City of Ryde Local Planning Panel Meeting No. 5/20

| 1 | 964-970 VICTORIA ROAD, WEST RYDE. CONSTRUCTION OF A 5 STOREY MIXED USE DEVELOPMENT CONTAINING A GROUND FLOOR RETAIL TENANCY AND BOARDING HOUSE USE COMPRISING 41 BOARDING ROOMS, 1 MANAGER'S UNIT AND 15 CAR SPACES IN 2 LEVELS OF CAR PARKING ACCESSED VIA MAXIM STREET. LDA2019/0325..... | 3 |

City of Ryde Local Planning Panel Report

Figure 11: Proposed stormwater and On Site Detention plan

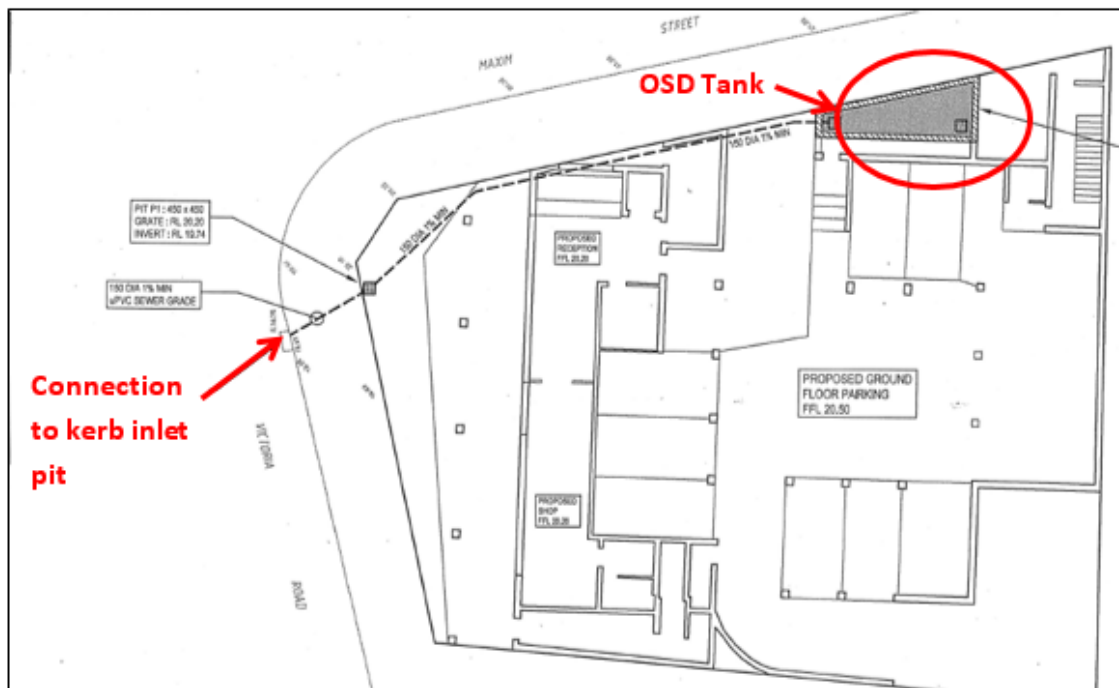
- The proposed stormwater management plan is inconsistent with the amended architectural plans and the proposed location of the On Site Detention (OSD) tank beneath the garbage storage room will cause potential contamination of stormwater.

The proposed stormwater management system includes an OSD tank beneath the garbage room and discharge to an existing kerb inlet pit in Victoria Road (see Figure 11).

The amended proposal includes an underground OSD tank located immediately beneath the garbage storage room adjacent to the eastern boundary. Council officers have raised concern that the location and design of the OSD tank may result in potential contamination through seepage from the garbage storage room to the OSD tank and stormwater system. This issue could be resolved with design modifications to the OSD tank and stormwater management plan, and could be conditioned.

Figure 12: Section plan (Section D-D) along southern boundary (Drawing No. D07, Issue. D)

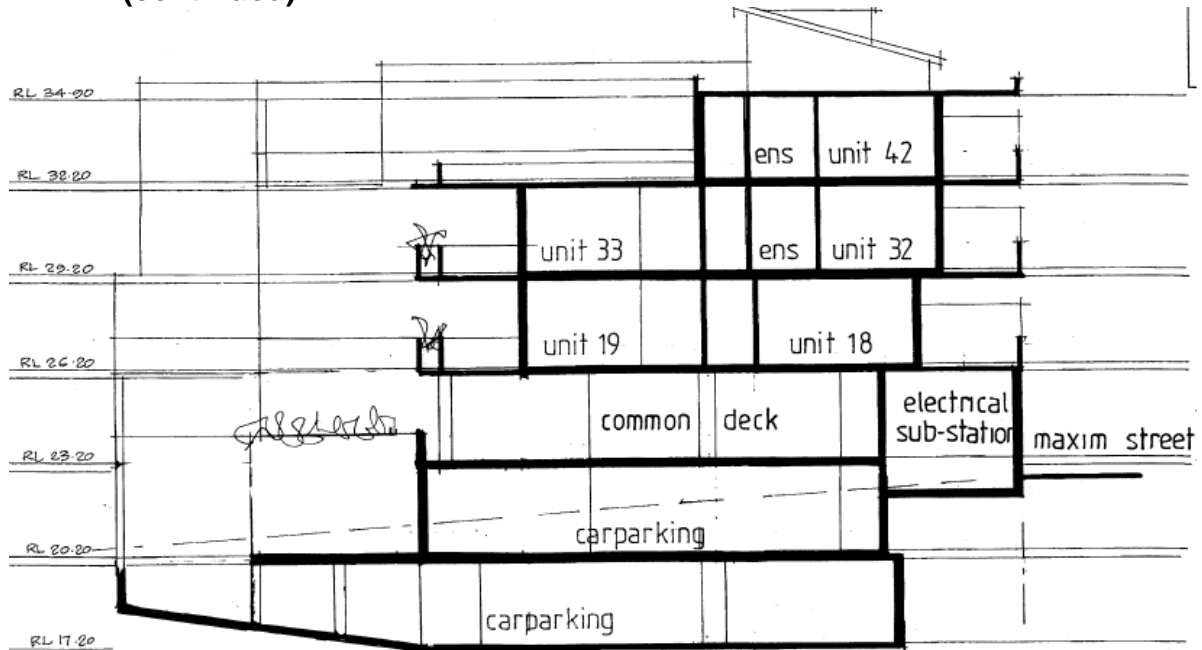
Along the southern and western boundaries the building steps back from the first floor to the fourth floor as shown at Figure 12. The communal open space on level one is setback between 5.2m and 8.9m from the western boundary and partially setback 7.6m to the southern boundary. The communal open space (labelled common deck at Figure 12) comprises a full height wall along the southern boundary.

Figure 15: Floor to ceiling height control for development in Victoria Road West Precinct (Part 4.3 of RDCP 2014)

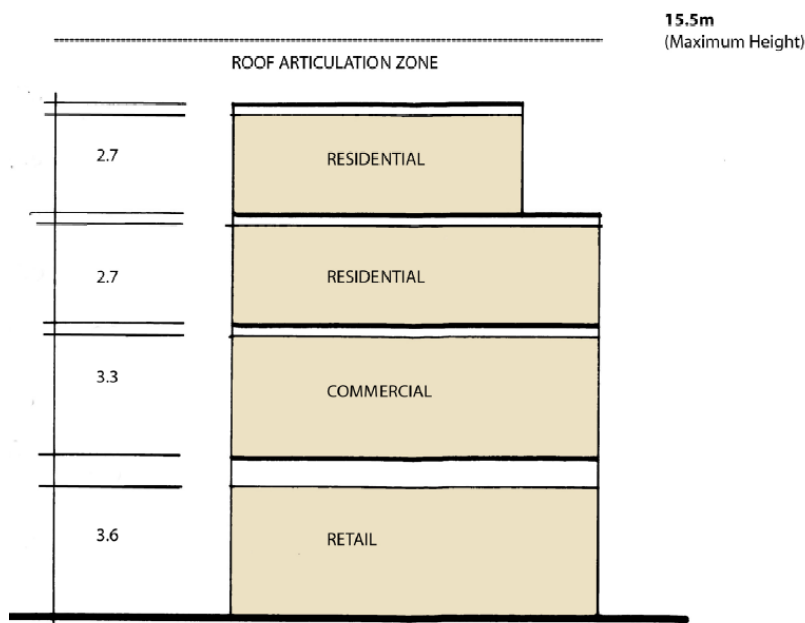
The proposed floor to ceiling height of 3m does not satisfy the minimum floor to ceiling height control of 3.6m for ground floor retail and commercial uses within the West Ryde Town Centre under the DCP. The proposal does not maximise opportunities to accommodate a wide range of retail or commercial uses over time and will detract from the pedestrian experience along Victoria Road. The non-compliant floor to ceiling height at ground floor level has enabled the proposal to present a 5 storey building within the 15.5m building height control. This is contrary to the floor to ceiling height and built form controls under Clause 3.1 in Part 4.3 of the RDCP 2014, which identifies that a maximum of 4 storeys would be capable of satisfying the built form provisions for the West Ryde Town Centre, and any higher would exceed the building height development standard under Clause 4.3 of the RLEP 2014 (see Figure 15). As such, the proposal presents a built form that is inconsistent with the proportions of a compliant development envisaged by the controls and will detract from the character of existing and desired future retail and commercial character in the Victoria Road West Precinct.

Figure 18: Proposed building height as shown on the East Elevation

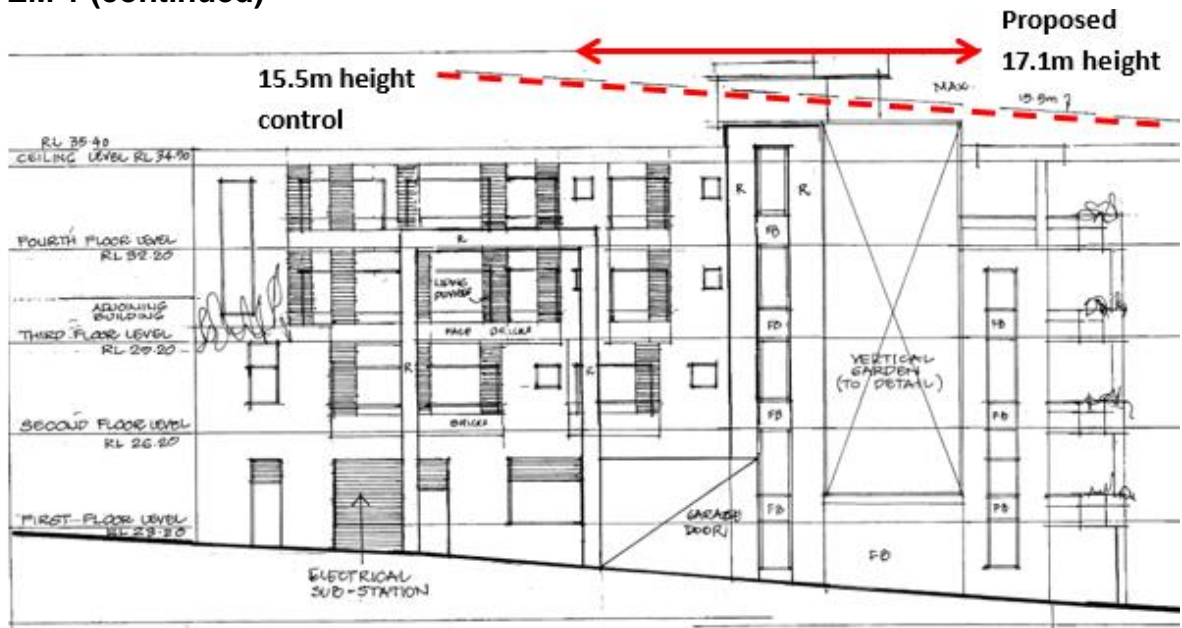
The proposal fails to comply with the development standard imposed by Clause 4.3 of the RLEP 2014 in respect to the maximum permitted building height of 15.5m. The proposal has a maximum building height of 17.1m, representing a 10.32% departure from the development standard. The applicant has failed to provide an adequate written request under Clause 4.6 of the RLEP 2014 to justify the breach in the building height development standard and the request is not supported.

Figure 19: Proposed building height exceedance view from the North Elevation

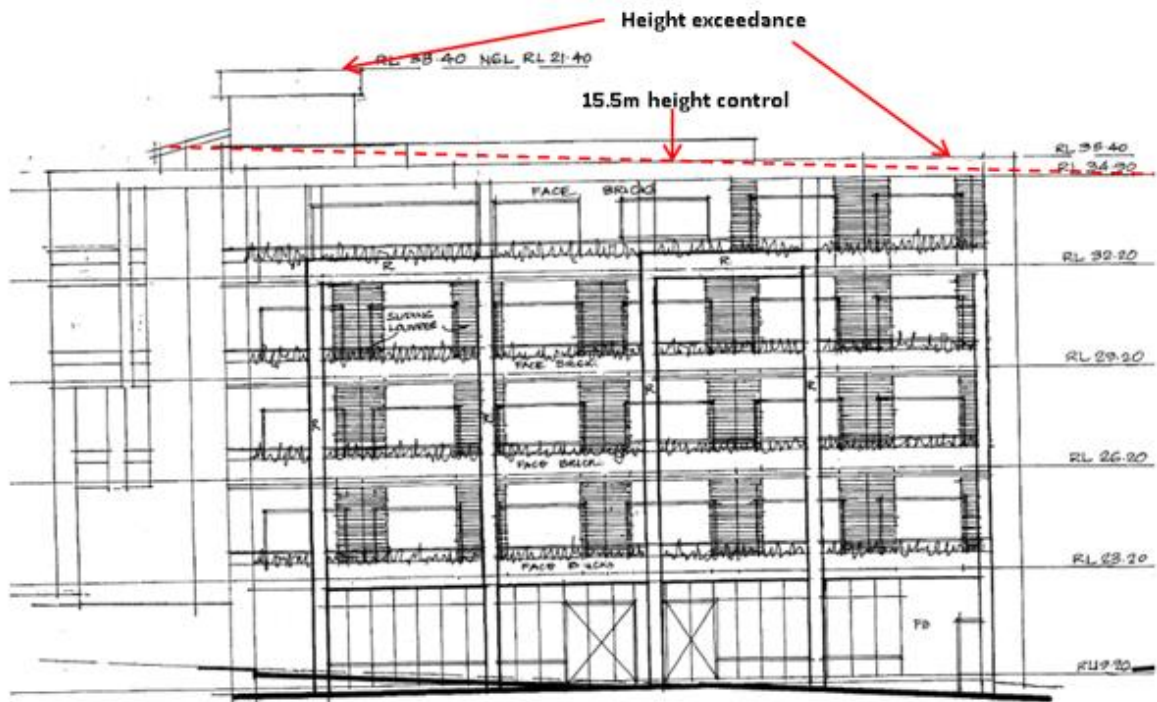
The parapet at the north-western corner of site also exceeds the maximum building height control by 0.3m (RL35.40) measured to the top of the parapet.
